AL BASRAH OIL TERMINAL
BASRAH, IRAQ

SIGIR PA-06-080
APRIL 26, 2007

SUBJECT: Report on the Al Basrah Oil Terminal, Basrah, Iraq (Report Number
SIGIR PA-06-090)

Al Basrah Oil Terminal, Basrah, Iraq

Figure 9. Original number and location of motorized lifeboats and life rafts on ABOT

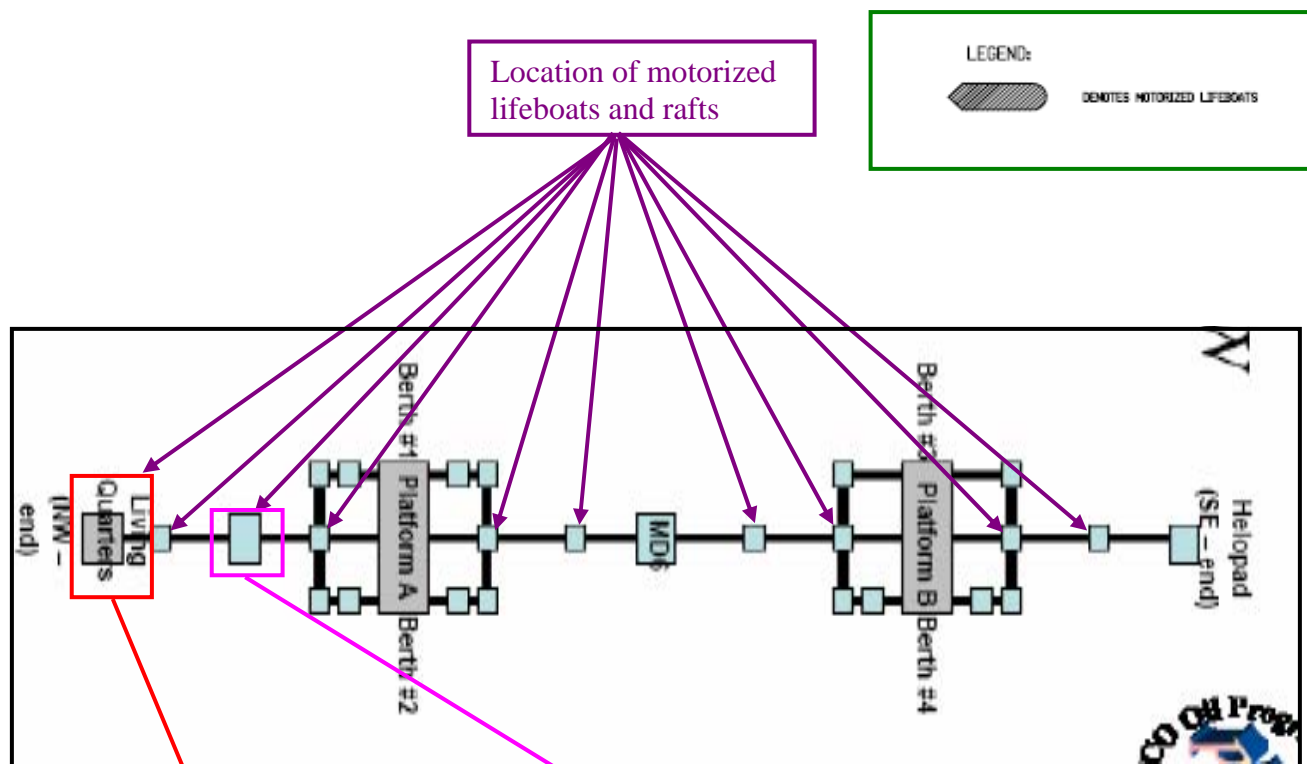
The original estimated cost for the project was approximately \$1.8 million. Figures 9, 10, and 11 show the number and location of the lifeboats and life rafts.

In May 2006, a revised SOW deleted the requirement for motorized lifeboats and reduced the project amount to \$425,188. GRD Oil representatives stated the requirement for motorized lifeboats was de-scoped due to funding limitations. A 13 June 2006 GRD briefing chart stated the new SOW required the contractor to “replace four existing lifeboats with fifteen 16-person capacity life rafts with cradles...Design and install the life raft deployment system.” However, on 22 May 2006, PIJV placed an order with the supplier for only eight life rafts.

Figure 15. Illustration of a fully inflated life raft (note life raft does not appear to hold 20 occupants)

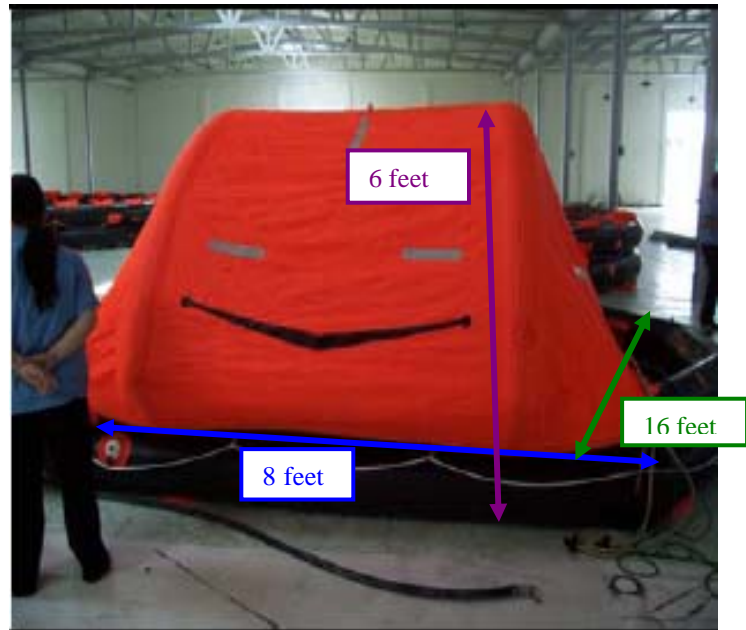
The information provided by the manufacturer did not include a photograph of the entire life raft, instead relying solely upon an illustration (Figure 15). The only photographs available of the life raft were provided by the company that inspected the life rafts. However, full length views of the front and rear of the life raft were not provided; instead only various angles of the life raft were available. Site Photos 22 and 23 provide an interior and exterior view of the life raft, respectively.

GRD representatives have stated the "the life rafts are totally enclosed," which complies with PIJV's specification that the "life raft shall have a canopy to protect the occupants from exposure..." The life raft chosen is not completely enclosed (Site Photos 24 and 25) and will not provide the occupants any protection from a major fire. In addition, GRD representatives stated that the life rafts are a "covered type design that would protect life raft from waves during heavy seas." According to GRD representatives, sea waves of approximately 15 feet are not uncommon for the ABOT area. We have concerns that this particular life raft, which is not fully enclosed and made of a soft skin cover, would survive long in such sea conditions.

Site Photos 24 and 25. Fully inflated life raft, which is not fully enclosed

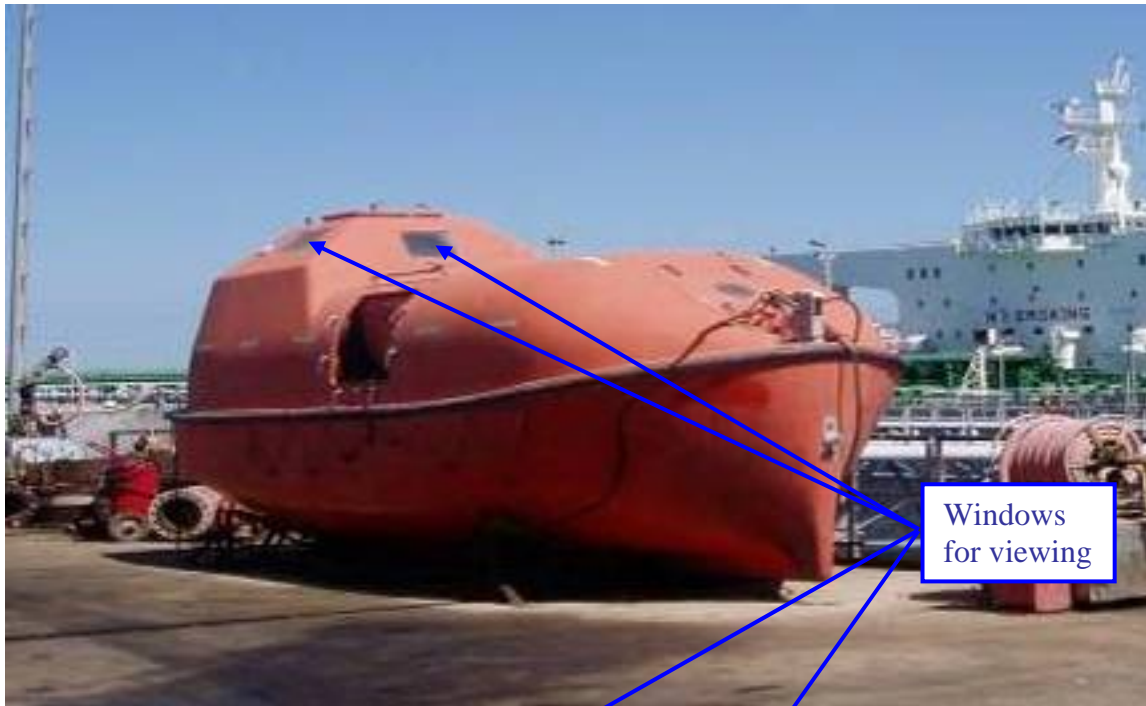
According to GRD Oil representatives, the standard for life raft is SOLAS and the life rafts procured comply with it; therefore, the life rafts are acceptable. However, this project was to provide "emergency and/or fast rescue boats" to be used in the "event of an emergency." The emergency described in PIJV's November 2005 PSSR was a "major fire." In the event of a major fire on the terminal, we believe the life rafts would not be an adequate means of escape. The existing escape capsules offer the best opportunity for survival not only because they are fully enclosed but they also provide front, rear, and side viewing to navigate through an ocean of burning oil (Site Photos 26 and 27).

Figure 16. Current location of the two existing evacuation escape capsules and eight life rafts

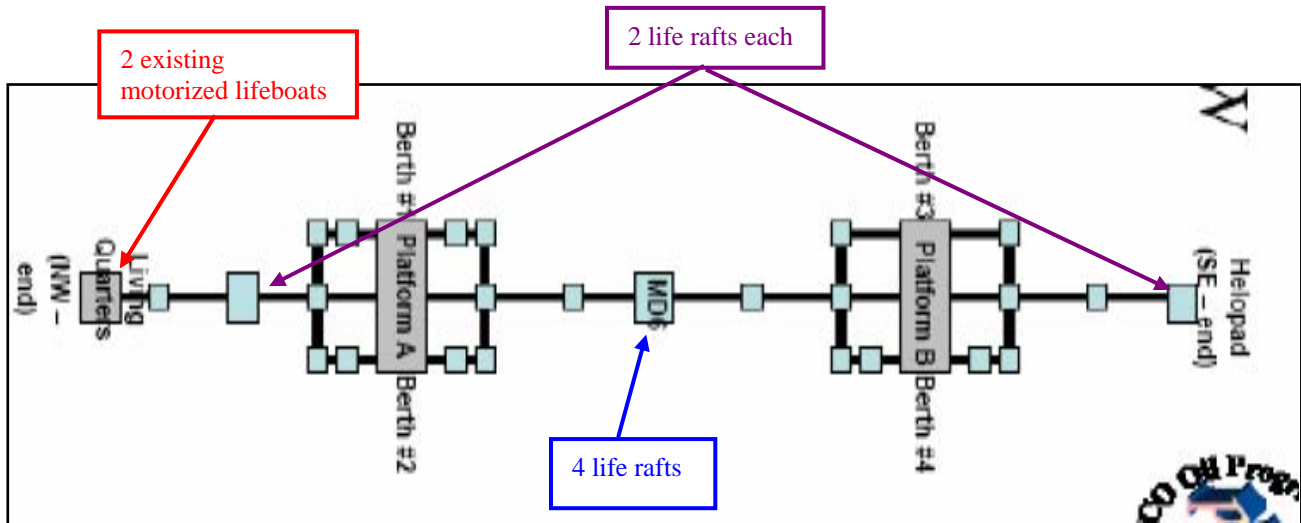
According to GRD representatives, the eight life rafts were installed at the helipad, MD6, and MD2 (Figure 16). Currently, there are no known muster points for an emergency evacuation on ABOT; therefore, we cannot determine if the life rafts were installed at the correct spots.
